Planning Stage Structural Report

150 Day Street

Prepared for UOL / 20th March 2025

Issue: Revision 2

DRAWING TITLE
BASEMENT 01 PLAN

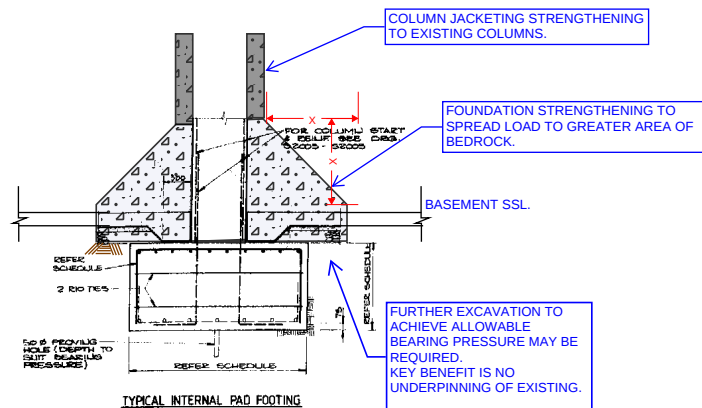
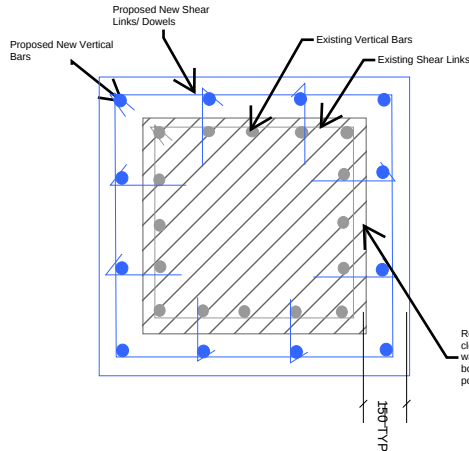
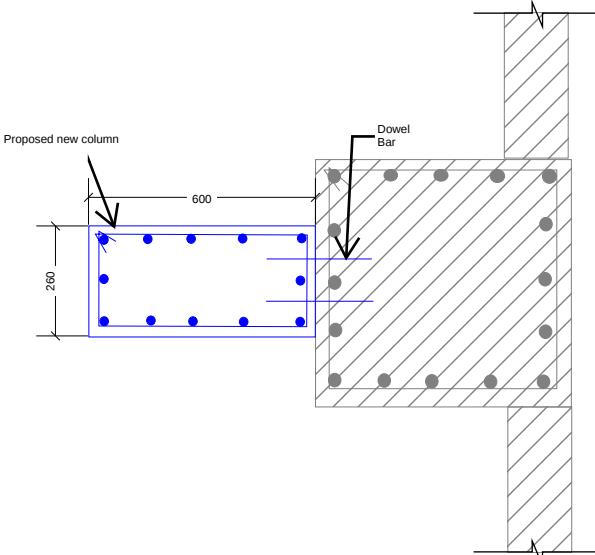
APPROXIMATE LOCATION OF GEOTECHNICAL
FAULT ZONE THROUGH SITE, WITH LOWER
ALLOWABLE BEARING CAPACITY

APPROXIMATE LOCATION OF CROSS
CITY TUNNEL.
DEPTH AND LOCATION TO BE
CONFIRMED, ALLOW FOR
CONSULTATION WITH STAKEHOLDERS
TO DISCUSS IMPLICATIONS OF
ADDITIONAL STOREYS ON FOUNDATION
FORCES.

ALLOW FOR EXCAVATION AND NEW FOOTING AT EACH LOCATION SHOWN DOTTED.
AT THESE LOCATIONS, EXISTING FOOTING WILL LIKELY REQUIRE EXTENSION TO
PROVIDE BASE TO STRENGTHENED PERIMETER COLUMN.

FOOTING TO BE ENTIRELY BELOW EXISTING BASEMENT SSL TO NOT INTERRUPT
EXISTING PLENUM AND DRAINAGE.
SEE COLUMN STRENGTHENING DETAILS IN THIS REVIEW SET FOR MORE
INFORMATION.
INTENTION AT THESE AREAS IS THAT BACK-PROPPING, JACKING AND
UNDERPINNING BE MINIMISED AND ELIMINATED IF POSSIBLE.

EXISTING LIFT CORE TO BE STRENGTHENED
BY WRAPPING WITH 350 THICK CONCRETE.
FOOTING STRENGTHENING VIA
UNDERPINNING SHOULD BE ALLOWED FOR AT
EXISTING LIFT LOCATION.

ALLOW FOR INTERNAL RETURN COLUMN ON INSIDE FACE. NEW LOADS FROM
ADDITIONAL STOREYS TO LOAD DIRECTLY INTO THESE EXTENSIONS.
PLAN GEOMETRY OF STRENGTHENED SECTION MAY BE MODIFIED, AT TYPICAL
HOTEL FLOOR INTENTION IS FOR COLUMN TO FIT WITHIN HOTEL WALL.

NOTE: STRENGTHENING NOT REQUIRED TO
INTERNAL COLUMN FOUNDATIONS AT B1
FOLLOWING 2024 GEOTECHNICAL
INVESTIGATIONS.

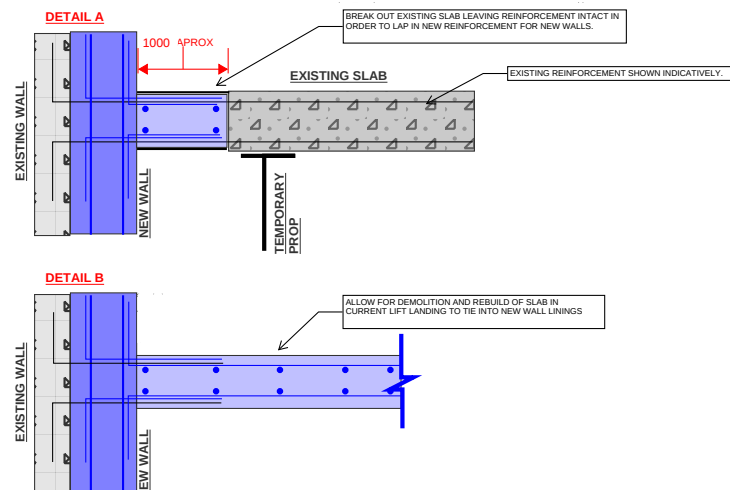
APPROXIMATE LOCATION OF SYDNEY WATER SEWER PIPE (300DIA VITRIFIED CLAY) AS IDENTIFIED IN DIAL BEFORE YOU DIG PLAN.

SEE TTW PLANNING STAGE REPORT FOR COMMENTARY ON IMPLICATIONS AND POTENTIAL REQUIREMENTS FOR A SYDNEY WATER SPECIAL ENGINEERING ASSESSMENT OF THIS ASSET.

DRAWING TITLE
GROUND FLOOR PLAN

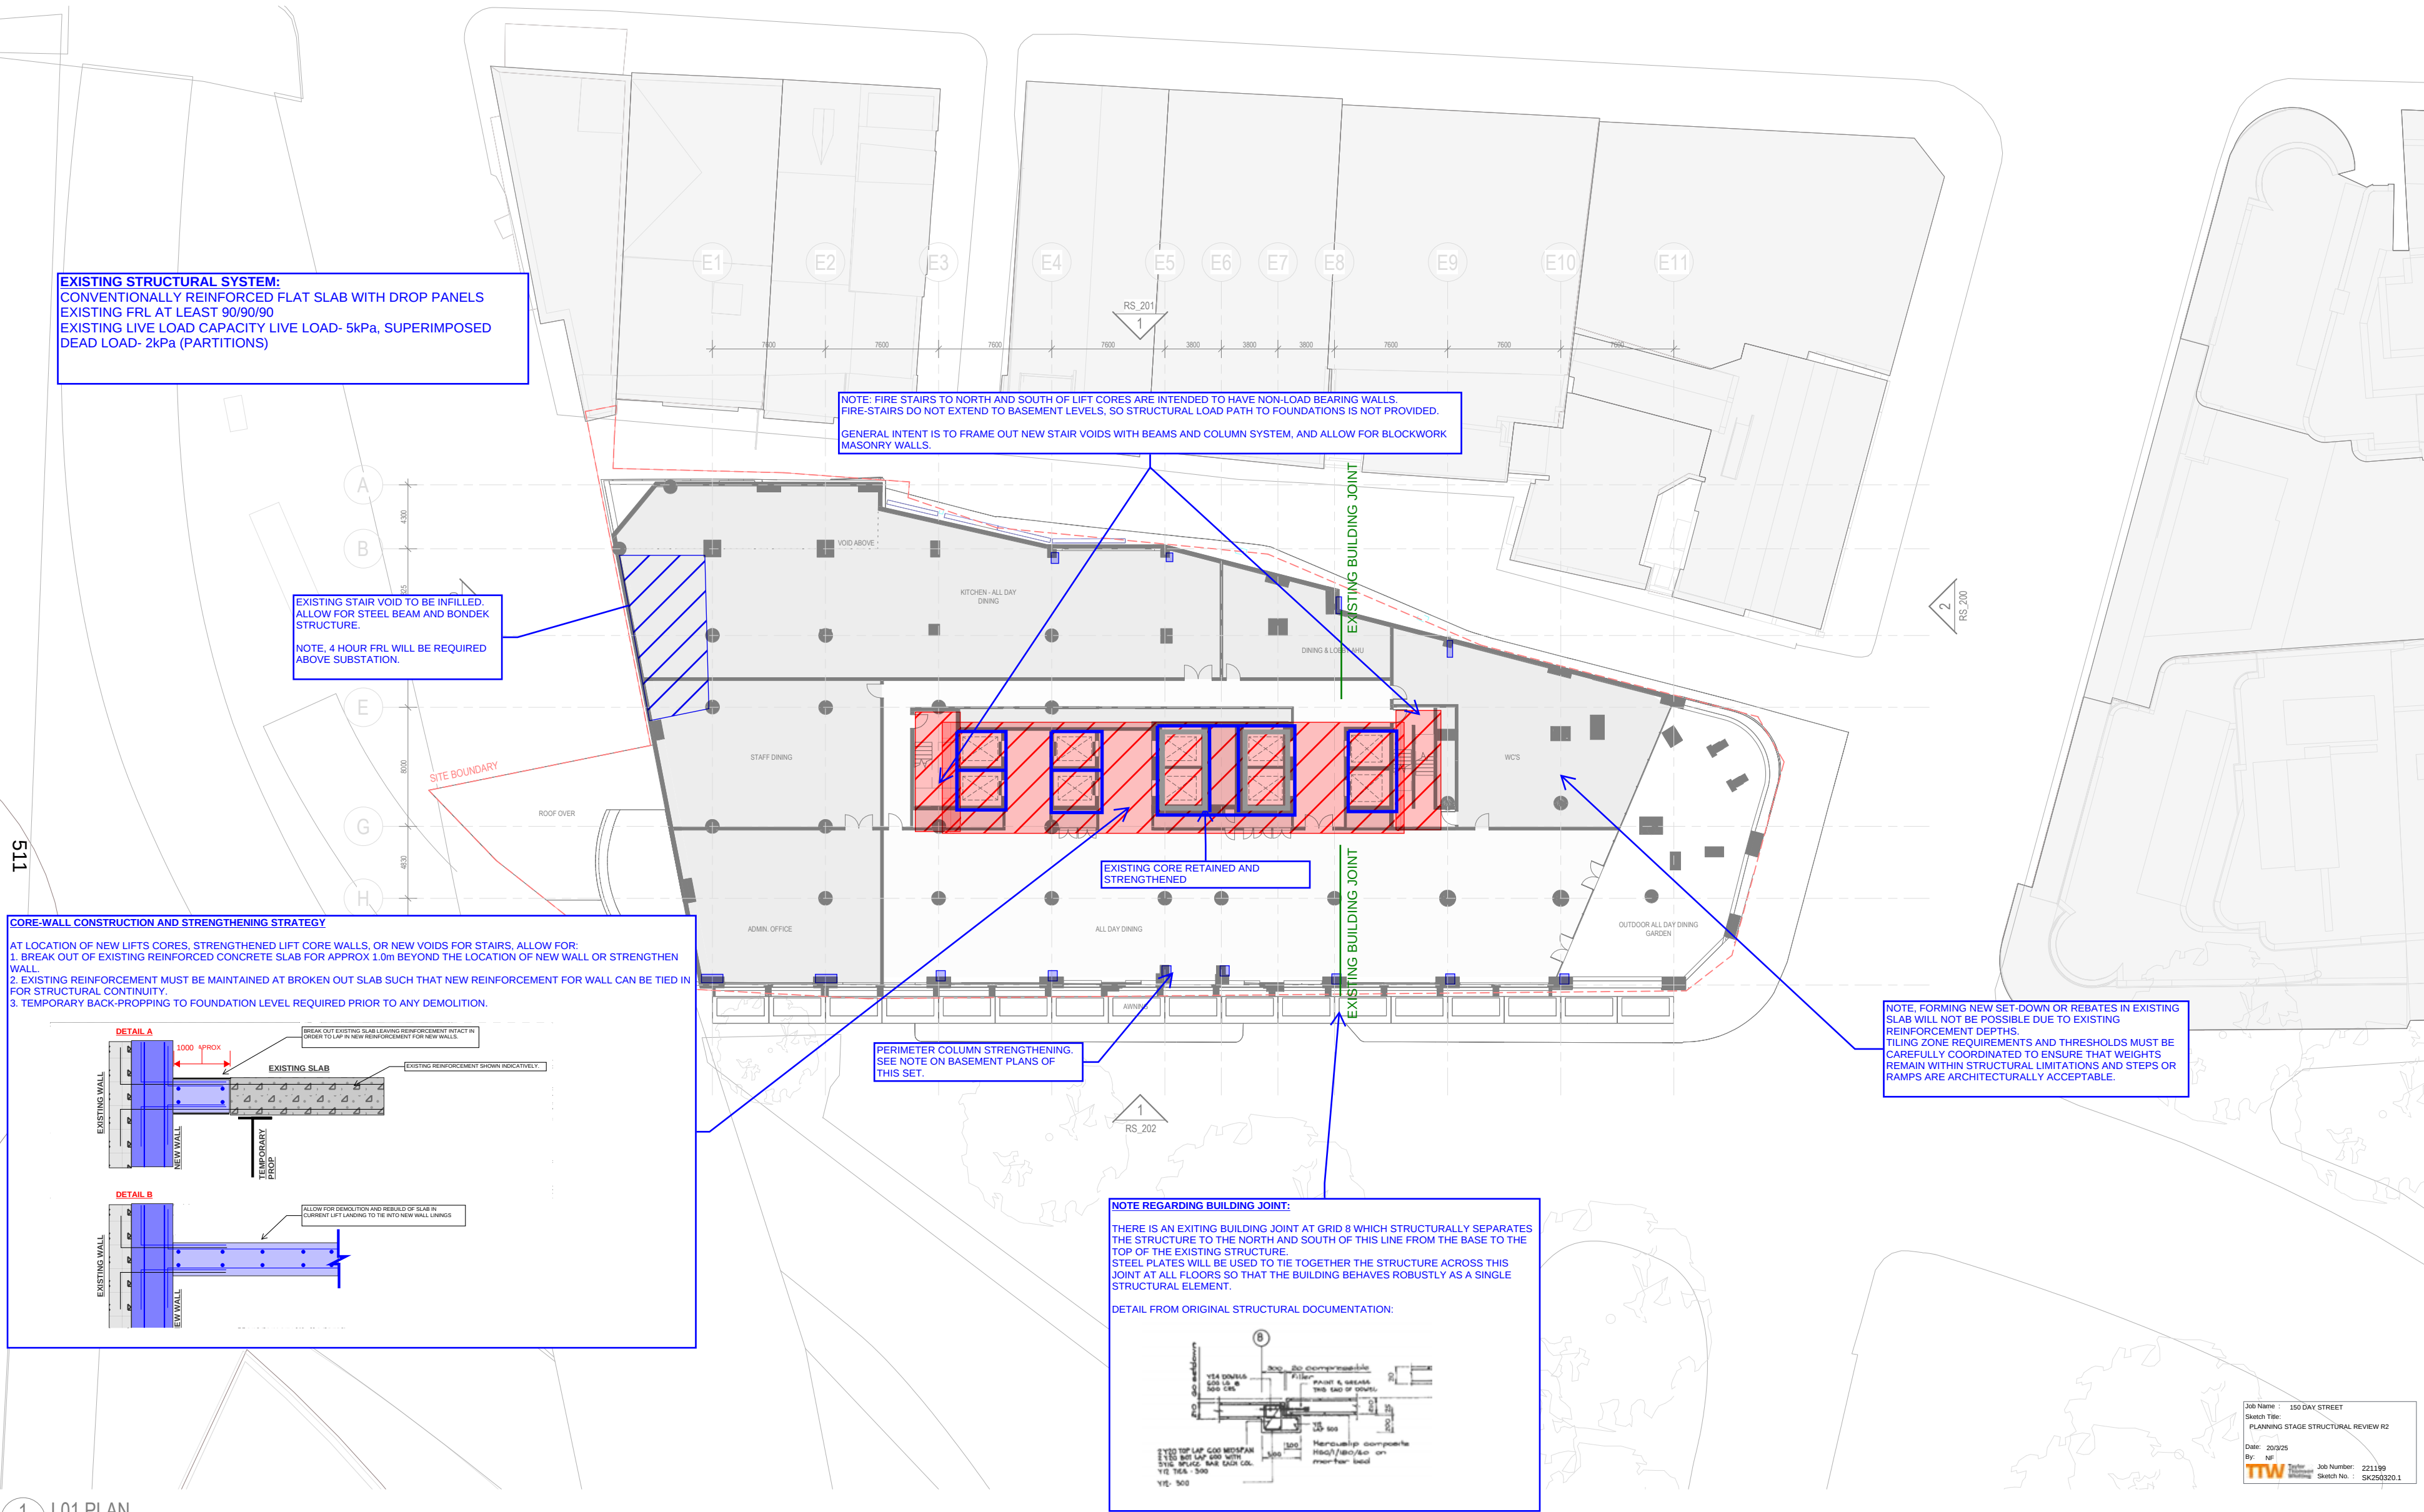
MODIFICATIONS TO SLAB WILL BE REQUIRED TO FACILITATE NEW VOIDS FOR STAIR PENETRATIONS. SPECIFIC REQUIREMENTS TO BE REVIEWED IN DETAILED DESIGN STAGE, ALLOW FOR TEMPORARY SUPPORT AROUND ALL TEMPORARY PENETRATIONS.

1. INTERNAL TEMPORARY PROPPING OF SHORING WALL ALONG SITE PERIMETER TO MAINTAIN STABILITY WHEN SLAB REMOVED.
2. OVER-BREAK OF EXISTING STRUCTURE BEYOND SUBSTATION EXTENT AS SHOWN. EXISTING REINFORCEMENT TO BE EXPOSED AND NEW REINFORCEMENT TO BE TIED TO PROVIDE STRUCTURE CONTINITY.
3. TEMPORARY PROPPING AT DEMOLITION PERIMETER TO BE PROVIDED.
4. TEMPORARY BRACING AT COLUMN LOCATIONS WITHIN DEMOLITION EXTENT TO BE PROVIDED TO ENSURE STABILITY WHEN SLAB REMOVED.

SEE GENERAL STRATEGY FOR
PERIMETER COLUMN STRENGTHENING
NOTED ON B2 PLAN.

COLUMNS HAVE BEEN BROUGHT DOWN THROUGH PREVIOUS OPEN SPACE IN ORDER TO AVOID OVERLOADING AND STRENGTHENING EXISTING TRANSFER BEAM AT L1 WHEN NEW LOADS FROM ADDITIONAL STOREYS IS ADDED. SPECIFIC DETAIL AT INTERFACE WITH L1 TO BE ASSESSED IN DETAILED DESIGN.

1 L03 PLAN
RS_020 1:200

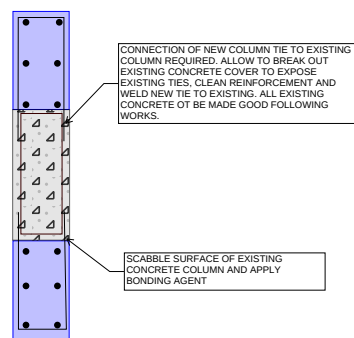
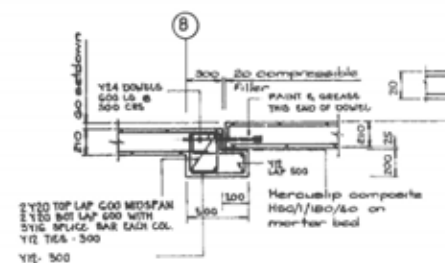
SEE REQUIREMENTS NOTED ON LOWER LEVEL PLANS
FOR STRUCTURAL IMPLICATIONS AND PROPOSED
METHODOLOGY OF CORE-REBUILD.

EXISTING FIRE STAIR AND ATRIUM VOID IN FILLED WITH STRUCTURAL STEEL BEAMS AND BONDEK IN ARRANGEMENT SHOWN.

GENERAL SOLUTION TO INFILL EXISTING
STAIR VOIDS WITH BONDEK AND
STRUCTURAL STEEL FRAMING.

SEE NOTE ON LEVEL 2 PLAN REGARDING
WHAT WOULD BE REQUIRED IN TERMS
OF BUILDING A NEW TRANSFER BEAM
TO REMOVE COLUMN AT L2.

PERIMETER COLUMN STRENGTHENING
GENERAL INTENT OF WORKS AS PER NOTES ON B2 SHEET OF THIS SET.

THERE IS AN EXISTING BUILDING JOINT AT GRID 8 WHICH STRUCTURALLY SEPARATES THE STRUCTURE TO THE NORTH AND SOUTH OF THIS LINE FROM THE BASE TO THE TOP OF THE EXISTING STRUCTURE. STEEL PLATES WILL BE USED TO TIE TOGETHER THE STRUCTURE ACROSS THIS JOINT AT ALL FLOORS SO THAT THE BUILDING BEHAVES ROBUSTLY AS A SINGLE STRUCTURAL ELEMENT.

DRAWING TITLE
LEVEL 03 PLAN

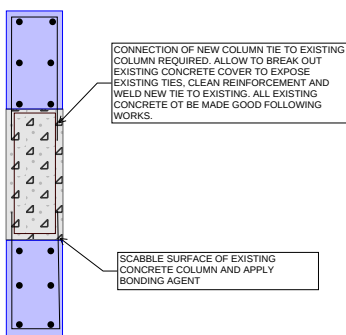
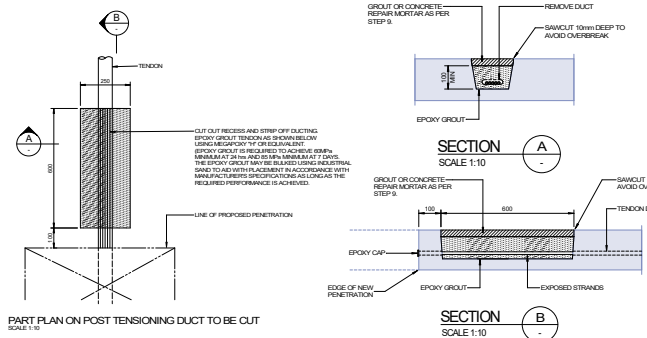
EXISTING STRUCTURAL SYSTEM:
POST-TENSIONED CONCRETE STRUCTURE
EXISTING FRL AT LEAST 90/90/90
EXISTING LIVE LOAD CAPACITY LIVE LOAD- 2kPa
SUPERIMPOSED DEAD LOAD- 2kPa (PARTITIONS)

SEE REQUIREMENTS NOTED ON LOWER LEVEL PLANS FOR STRUCTURAL IMPLICATIONS AND PROPOSED METHODOLOGY OF CORE-REBUILD.

EXISTING FIRE STAIR AND ATRIUM VOID IN FILLED WITH STRUCTURAL STEEL BEAMS AND BONDEK IN ARRANGEMENT SHOWN.

PERIMETER COLUMN STRENGTHENING
GENERAL INTENT OF WORKS AS PER NOTES ON B2 SHEET OF THIS SET.

NOTE ON REQUIREMENTS FOR TRUNCATING EXISTING POST-TENSIONING.

FOR NEW LIFT AND STAIR SOUTH OF GRID E8 IN PARTICULAR.

TRUNCATION OF EXISTING POST-TENSIONING WILL BE REQUIRED TO FORM NEW OPENING FOR LIFT AND STAIR VOID. DETAILED ANALYSIS REQUIRED AT NEXT DESIGN STAGE IN ORDER TO ASSESS ANY ADDITIONAL STRENGTHENING IN ADJACENT SLAB WHICH MAY BE REQUIRED TO FACILITATE THIS TRUNCATION.

LEVEL 11 PLAN TRANSFER FLOOR

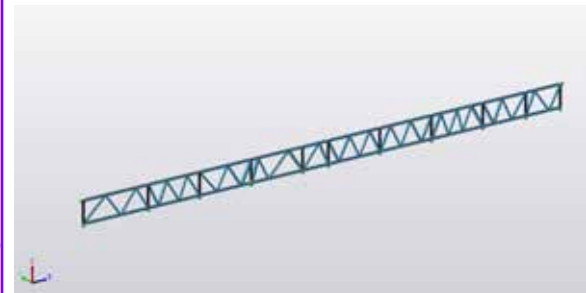
ALLOW FOR STRENGTHENING TO EXISTING L11 STRUCTURE TO FACILITATE CHANGE OF USE. STRENGTHENING MAY BE ACHIEVED BY A GRILLAGE OF BEAMS ABOVE THE EXISTING SLAB (HIDDEN WITHIN AN ACCESS FLOOR) TO SUPPORT THE WEIGHTS OF PLANT, LANDSCAPE AND POOL LOADS.
THIS STRENGTHENING COULD BE INCORPORATED INTO A CONSTRUCTION CRASH DECK WHICH WOULD BE INSTALLED TO ALLOW FOR CONSTRUCTION OF THE ADDITIONAL STOREYS WHILE ACCESS IS MAINTAINED BELOW FOR MODIFICATION AND FIT-OUT WORKS,
EXISTING CONCRETE TOPPINGS MUST BE REMOVED FROM THIS SLAB TO MINIMISE EXISTING WEIGHT PRIOR TO NEW WORKS TAKING PLACE.
RENOVATION WORKS IN THE 1990s INCLUDED ADDITION OF NEW TOPPINGS WHICH HAVE REDUCED AVAILABLE STRUCTURAL CAPACITY BELOW ORIGINAL DESIGN INTENT.

EXISTING STRUCTURAL SYSTEM:
POST-TENSIONED CONCRETE STRUCTURE
EXISTING FRL AT LEAST 90/90/90
EXISTING LIVE LOAD CAPACITY LIVE LOAD- 3kPa TYPICALLY, 7.5kPa IN EXISTING PLANT-ROOM.

NOTE ON HEAVY PLANT EQUIPMENT
HEAVY PLANT WILL REQUIRE STEEL GRILLAGE AT LOW LEVEL FOR STRUCTURAL SUPPORT IN ORDER NOT TO OVERLOAD EXISTING SLAB.
GENERAL INTENTION IS TO PROVE AND ACCESS FLOOR OVER LOW-LEVEL STEEL BEAM GRILLAGES.
STRUCTURAL REVIEW ON EIGHTS OF PLANT, INCLUDING PLINTHS, MUST BE CARRIED OUT TO EXISTING STRUCTURE IS NOT OVERLOADED.
HEAVY PLANT SHOULD BE LOCATED CLOSE TO STRUCTURAL SUPPORTS (COLUMNS) AND LIGHT-WEIGHT PLINTHS SPECIFIED TO MINIMISE STRENGTHENING REQUIREMENTS.

AT BUILDING PERIMETER, COLUMN TRANSFER COULD BE ACHIEVED BY TRUSSES, OR BY DEEP STRUCTURE, POTENTIALLY HIDDEN WITHIN THE DEPTH OF THE PROPOSED PLANTER BEDS.
ALLOW FOR 1200WB455 TO TRANSFER LOADS FOR INDICATIVE COSTING.

STRUCTURAL REQUIREMENTS TO SUPPORT WEIGHT OF POOL PLANT MUST BE REVIEWED IN DETAIL WITH INPUT FROM A POOL CONSULTANT.
IN GENERAL, WE WOULD EXPECT THAT A POOL CONSULTANT BE ENGAGED IN ORDER TO PROVIDE SPECIALIST ADVICE REGARDING PLANT, SPATIAL LAYOUTS AND REQUIREMENTS FOR BALANCE TANKS.

GENERAL STRUCTURAL SOLUTION TO PROVIDE FULL STOREY STEEL TRUSSES TO TRANSFER COLUMN LOADS AT THIS STOREY.
TRUSSES TO BE ARRANGED IN NORTH-SOUTH ORIENTATION OVER EXISTING COLUMN GRID LOCATIONS AS INDICATED.
LOWER STEEL-TONNAGE SOLUTIONS WILL BE ACHIEVED WITH IRREGULAR WARREN TRUSSES WHICH DIRECTLY TRANSFER COLUMN LOADS BY DIAGONALS AT EXACT REQUIRED LOCATIONS.
NOMINALLY, AN IRREGULAR TRUSS WITH OPTIMISED GEOMETRY WILL REQUIRE APPROXIMATELY HALF THE STEEL TONNAGE OF A REGULAR TRUSS.
OPTION 1: OPTIMISED IRREGULAR TRUSS
TOTAL STEEL WEIGHT FOR COSTING, APPROXIMATELY 450kg/m

AT BUILDING PERIMETER, COLUMN TRANSFER COULD BE ACHIEVED BY TRUSSES, OR BY DEEP STRUCTURE, POTENTIALLY HIDDEN WITHIN THE DEPTH OF THE PROPOSED PLANTER BEDS.
ALLOW FOR 1200WB455 TO TRANSFER LOADS FOR INDICATIVE COSTING.

NOTE ON DEEP PLANTER ZONE AND INTEGRATED TEMPORARY WORKS DECK AT L11
INCLUSION OF DEEP PLANTER ZONE AT L11 WILL REQUIRE EXTENSIVE STRENGTHENING OF EXISTING STRUCTURE DUE TO INCREASED WEIGHT.
AS WE WILL BE BUILDING ABOVE THE EXISTING HOTEL FROM THIS FLOOR, THERE WILL BE EFFICIENCIES IN INCORPORATING THIS STRENGTHENING INTO A CRASH-DECK AND CONSTRUCTION PLATFORM WHICH WILL ALLOW FOR SAFE CONSTRUCTION ABOVE THE EXISTING STRUCTURE.
